Review of Pape Avenue TOC Noise and Vibration Considerations

Ontario Line Technical Advisor

December 2022

- Receptor ID - single
- Receptor IDs - multiple levels at given location on facade

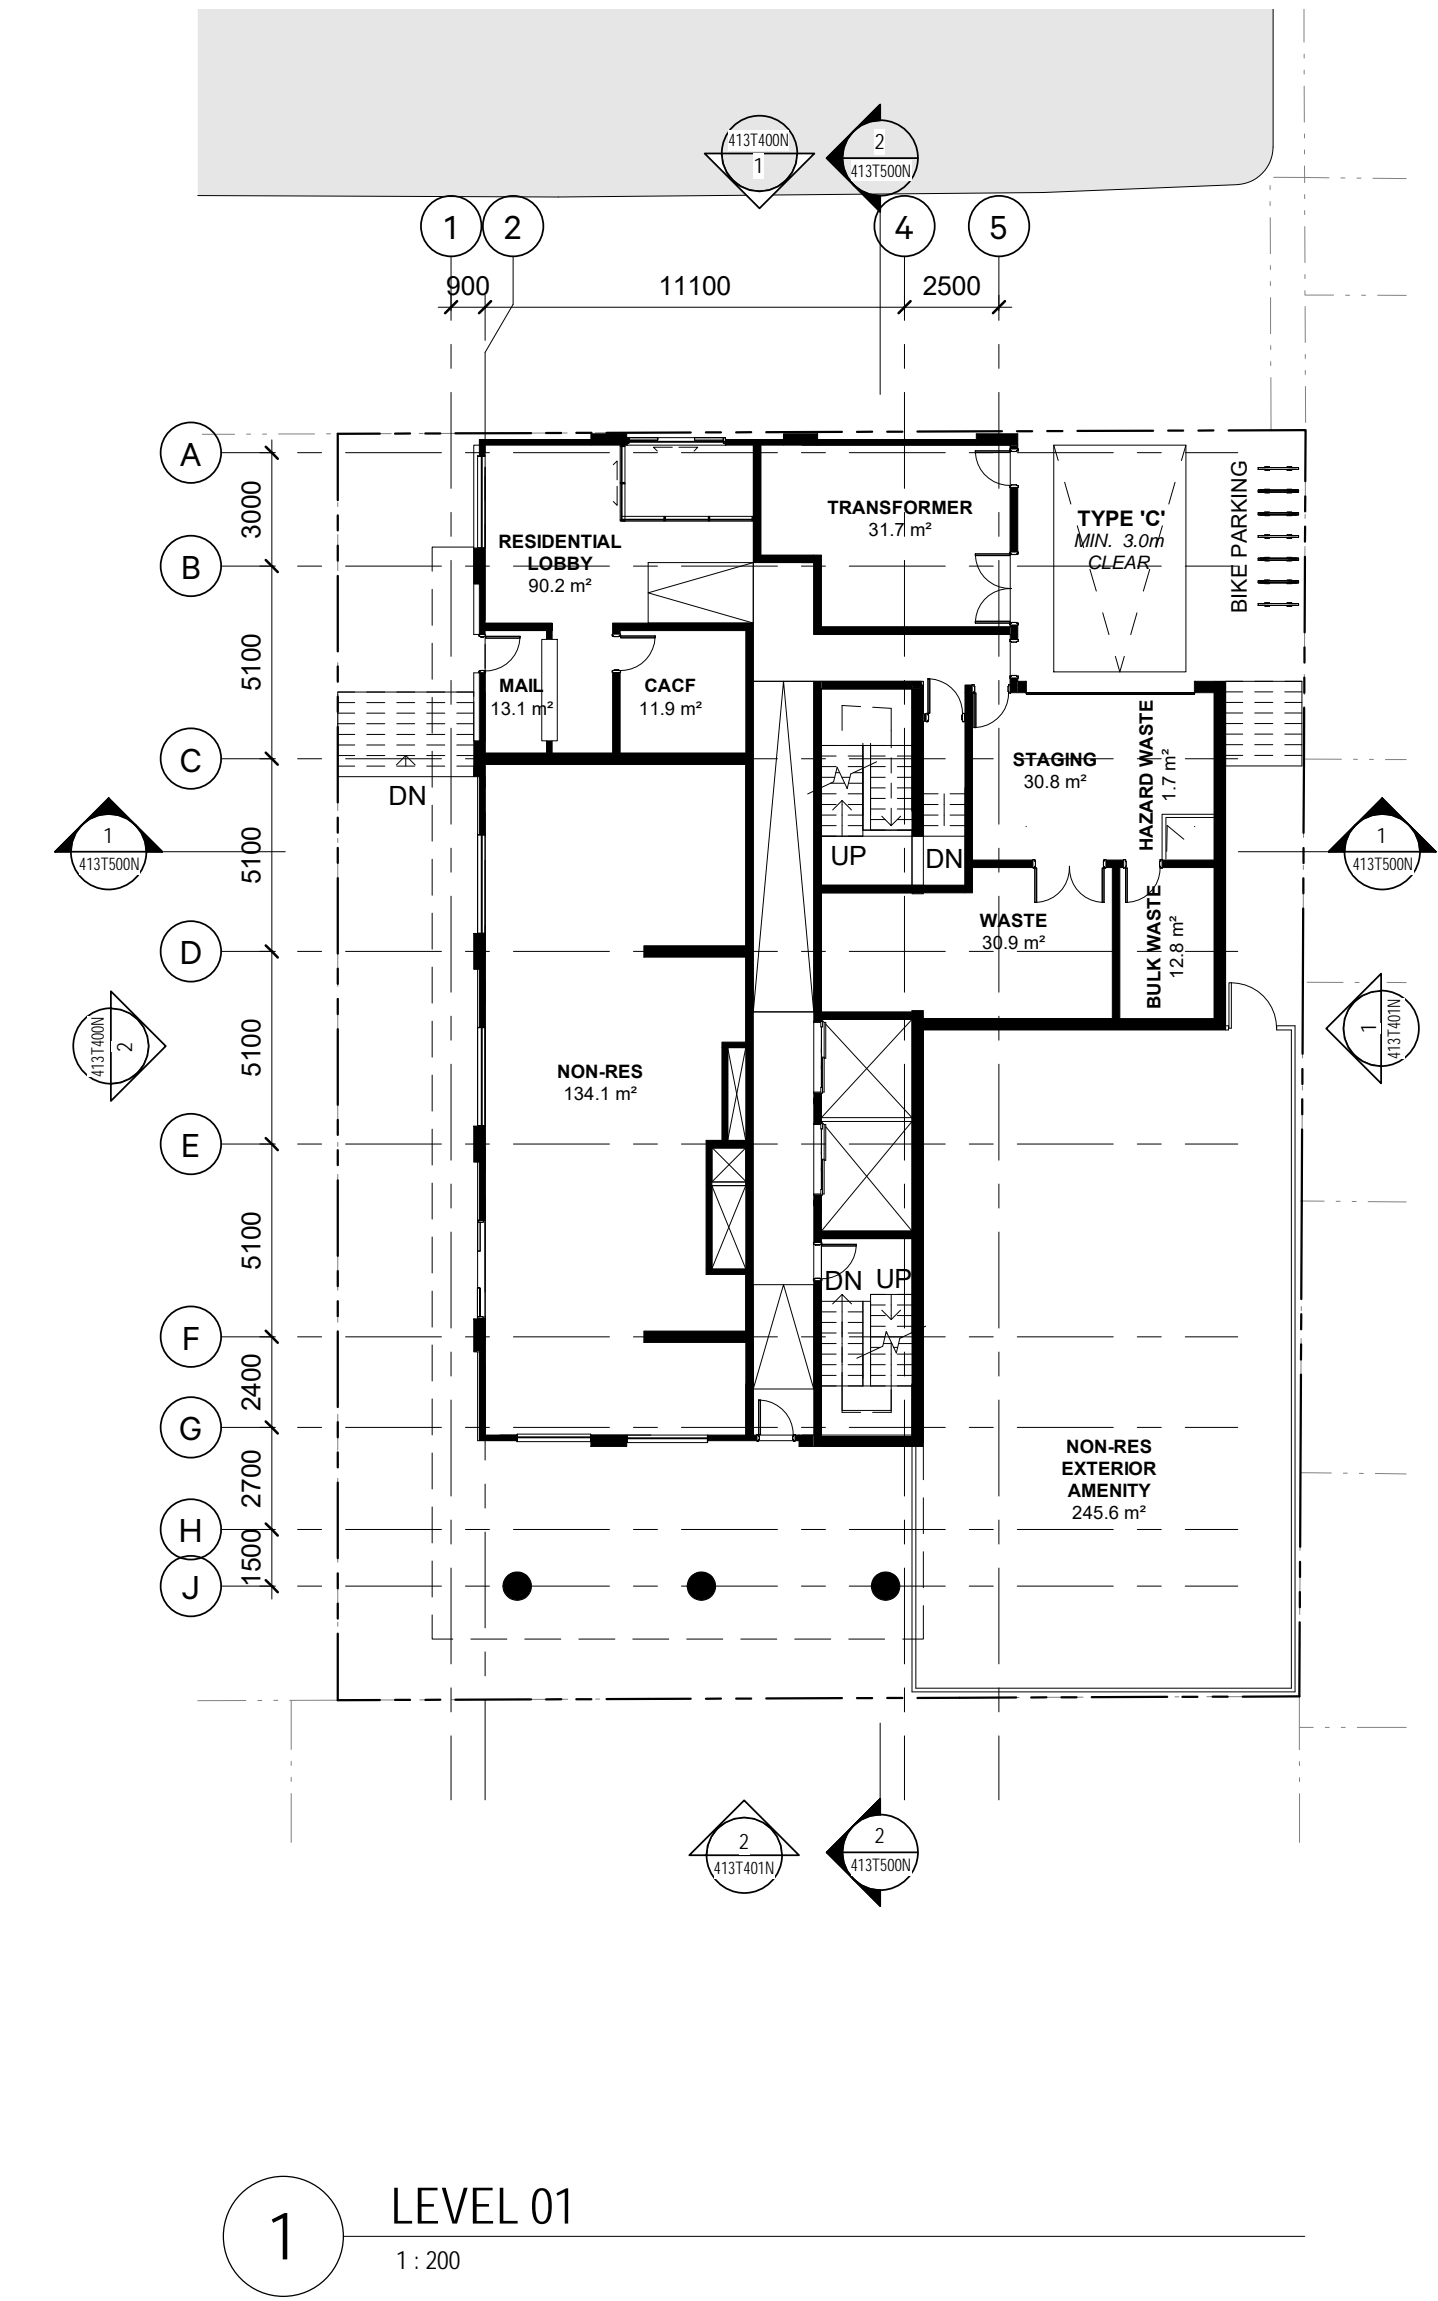
The predicted noise levels from the station noise sources show that sound levels at most the POW receptors are expected exceed Class 1 nighttime noise limit of 45 dBA. Noise levels without TTC busses were also predicted at the receptors and presented for information purpose.

1. Section lines from drawings 413T201N and 413T202N.
2. Plane of Window nighttime noise limit for Class 1 Area, MECP NPC-300.

- Adding enclosed balconies for the areas where exceedance is identified (i.e., North Site and South Site balconies facing the EEB condenser yard and ventilation openings).
- Moving residential units away from the impacted areas and/or positioning sleeping areas to the sides of the building not facing the station noise sources.
- Incorporating other massing design changes to provide additional shielding from noise sources⁴.
- Criteria adjustments by consideration of a Class 4 acoustical area designation by the land use planning authority, discussed below.

Plot Date: 03 October 2022
METROLINX
Infrastructure Ontario
Dwg. No. 413A100 Sheet No. 07 of 23

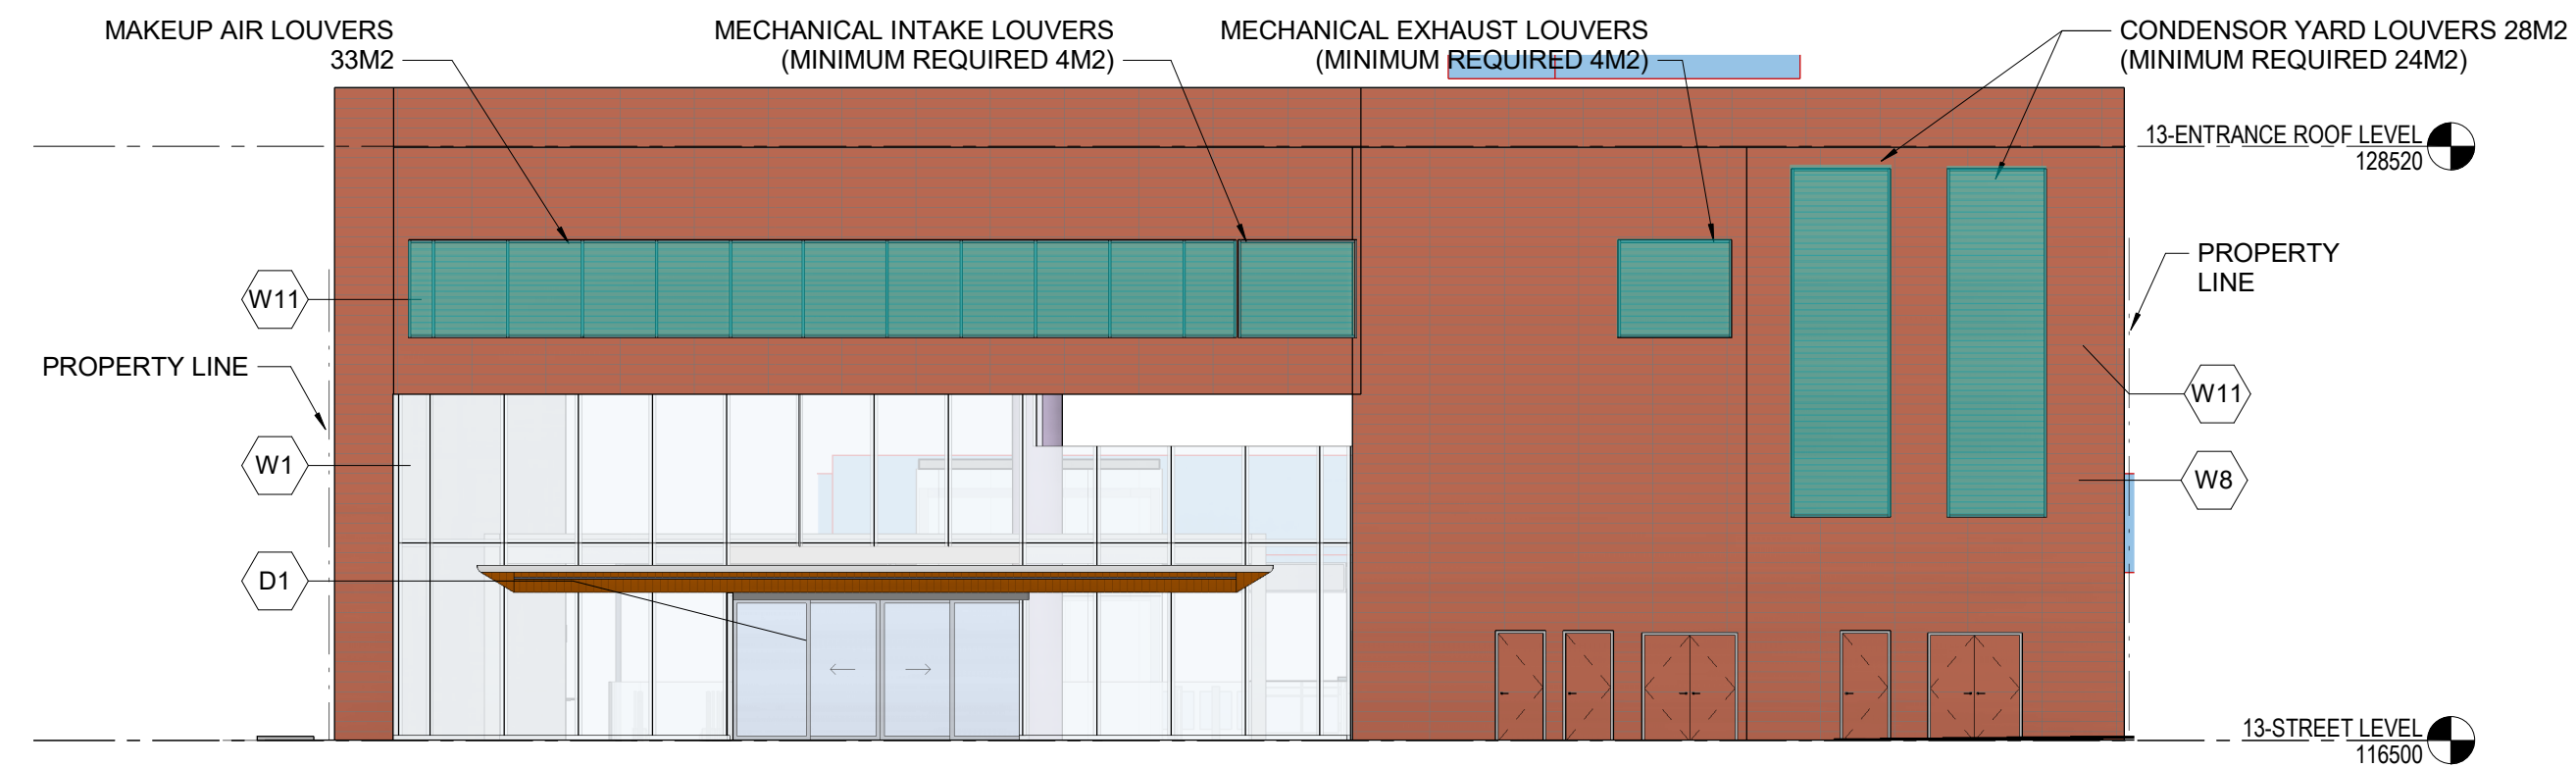
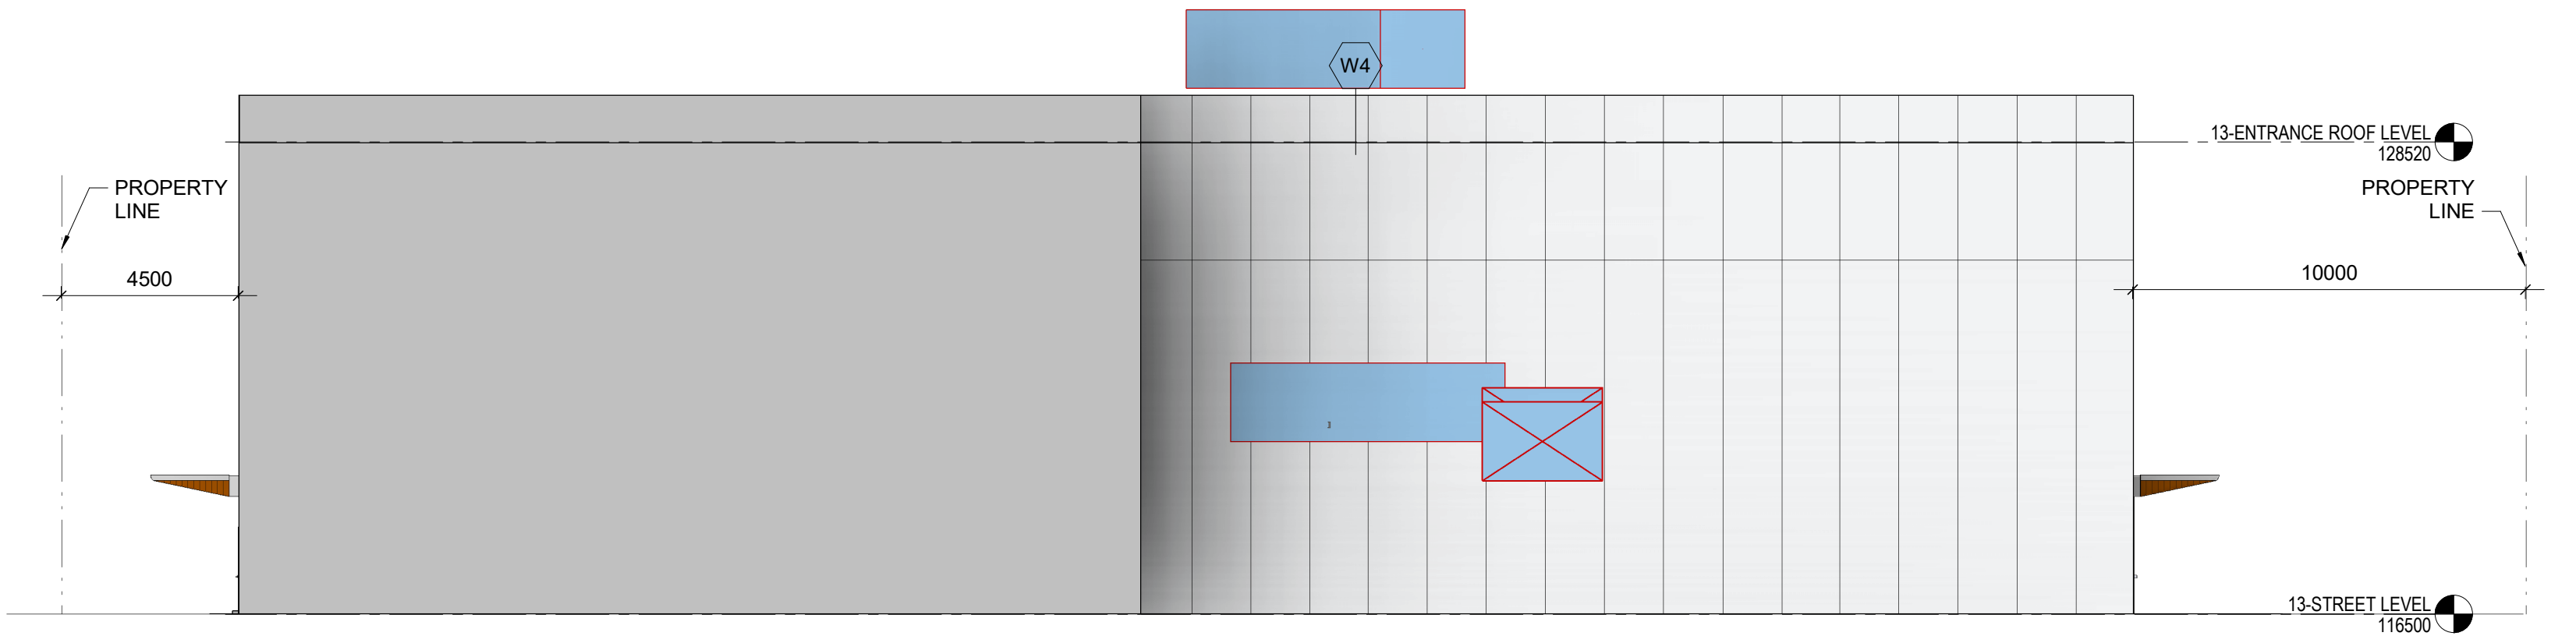
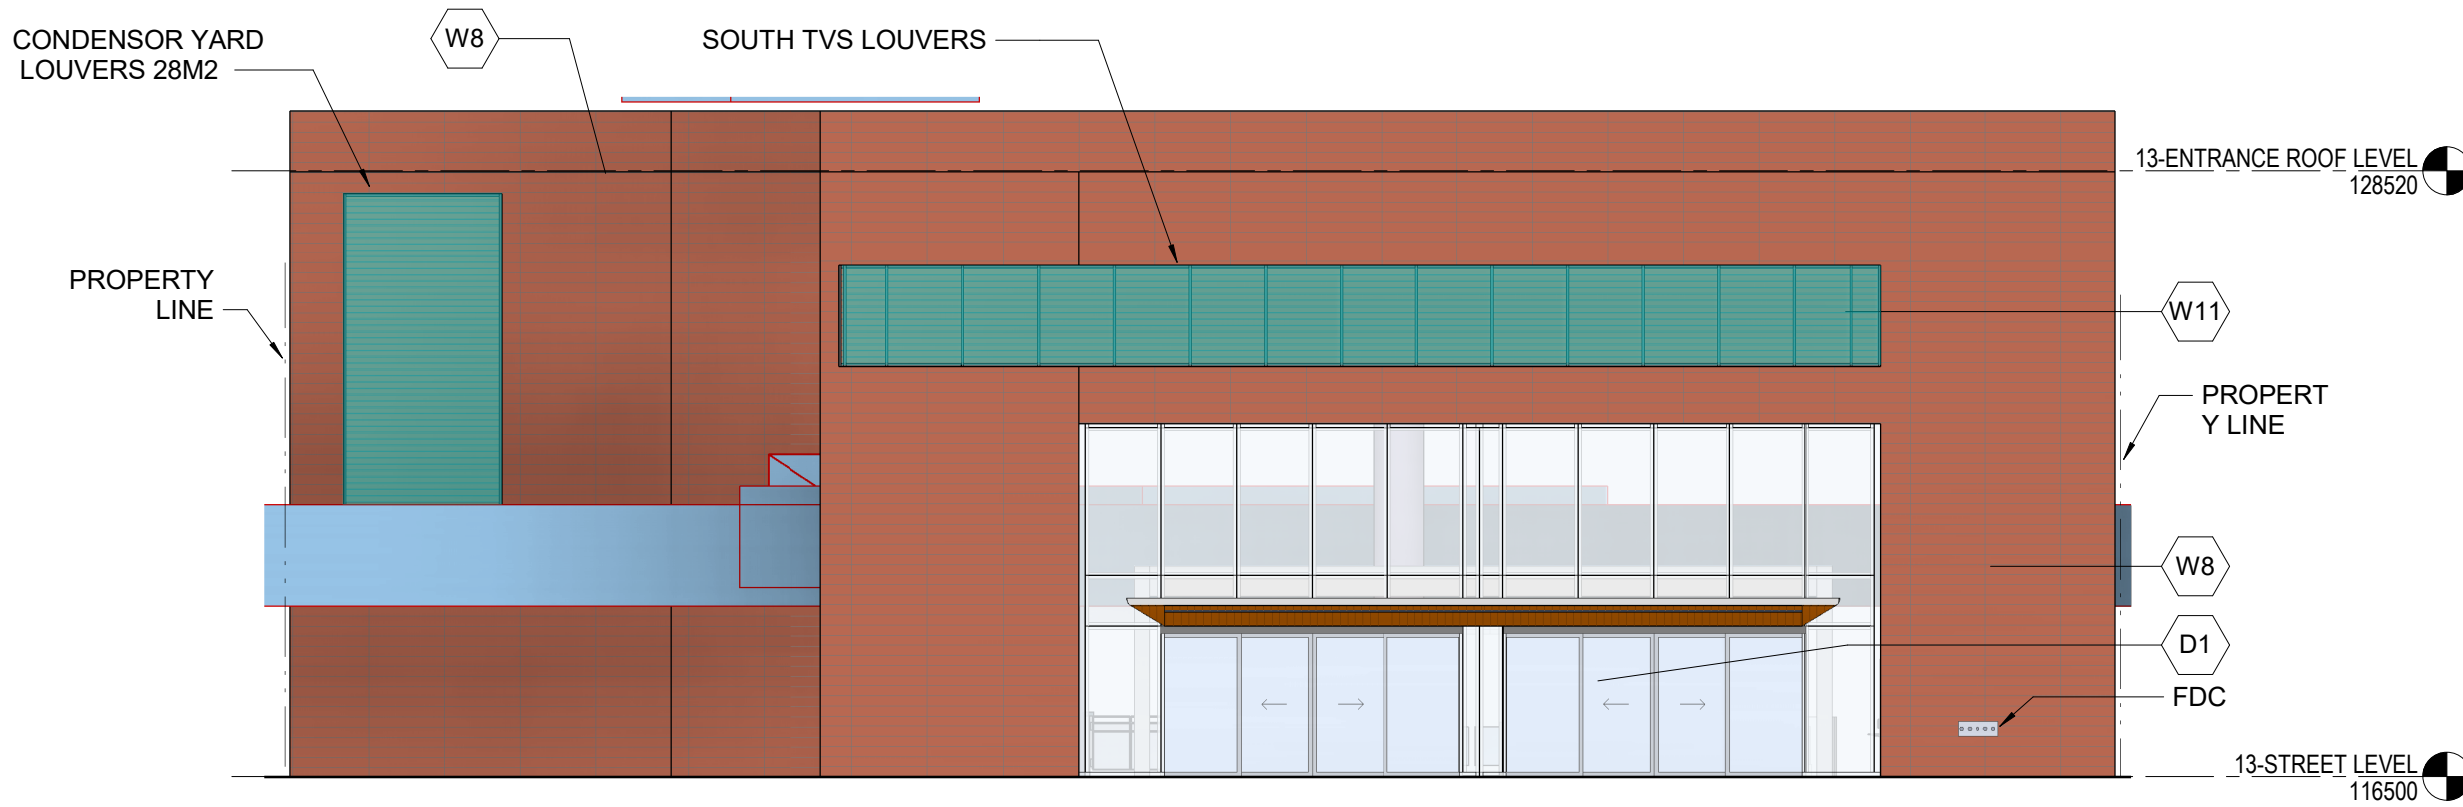
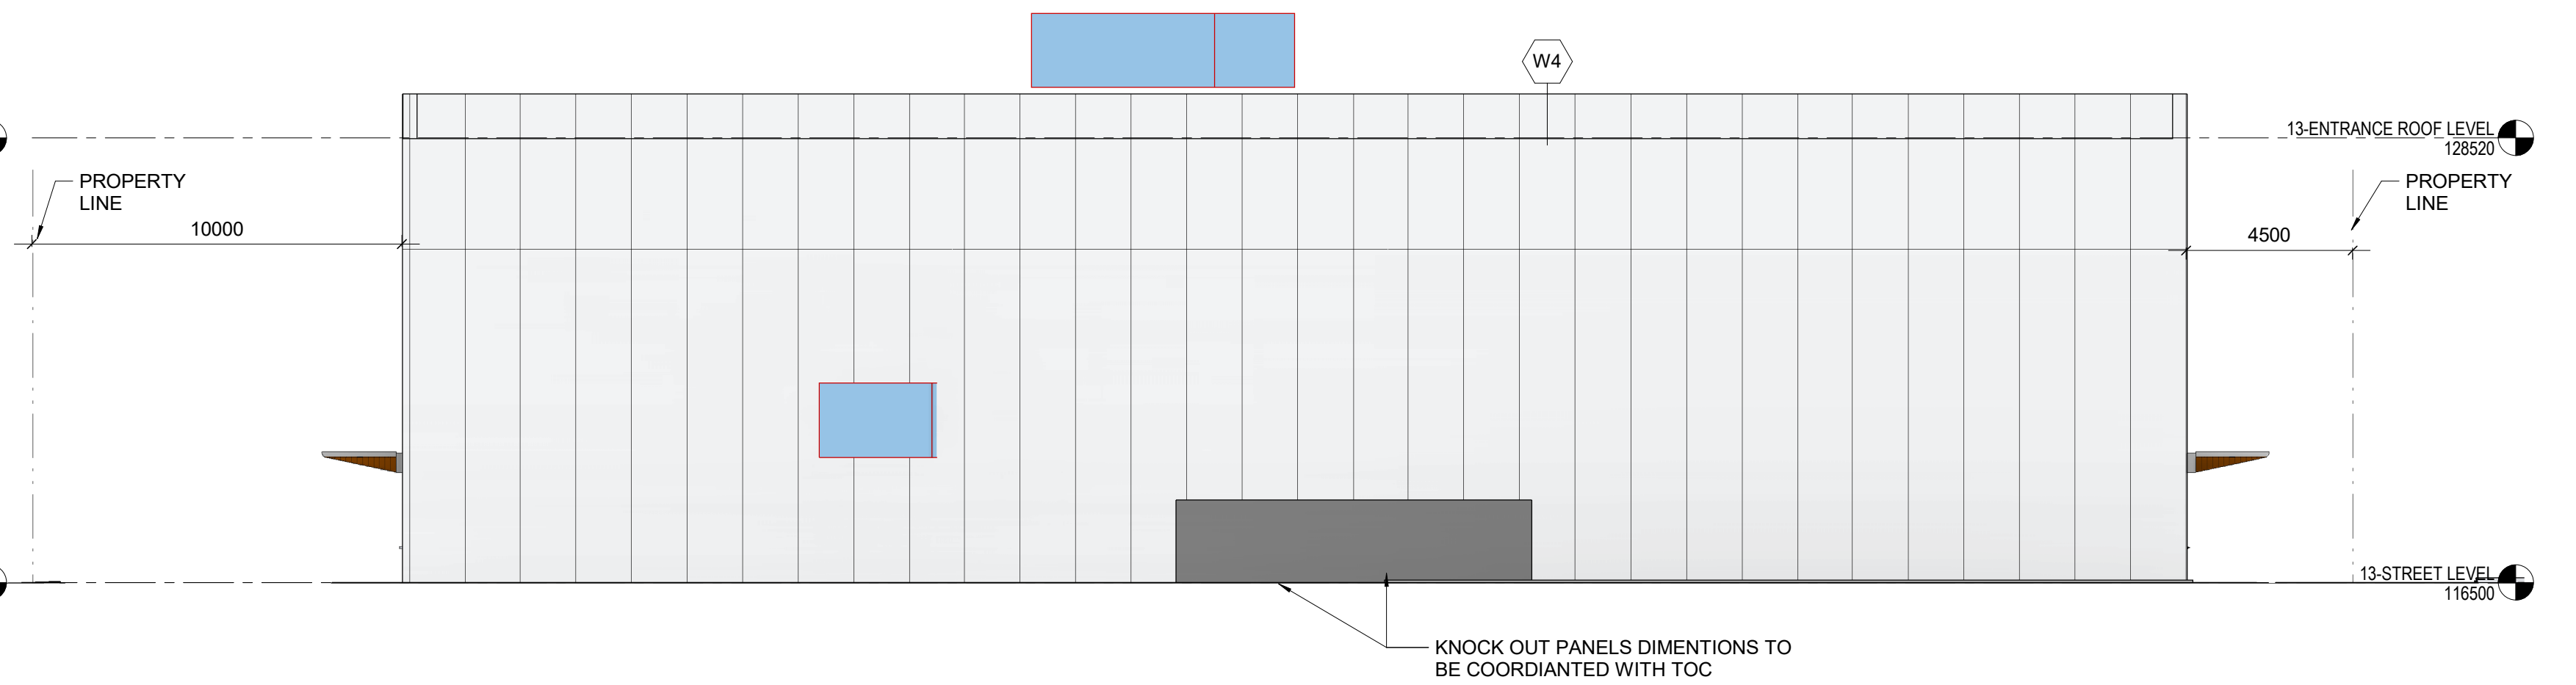
All louvers modelled as vertical area sources, assume limit of 60 dBA at 1 m
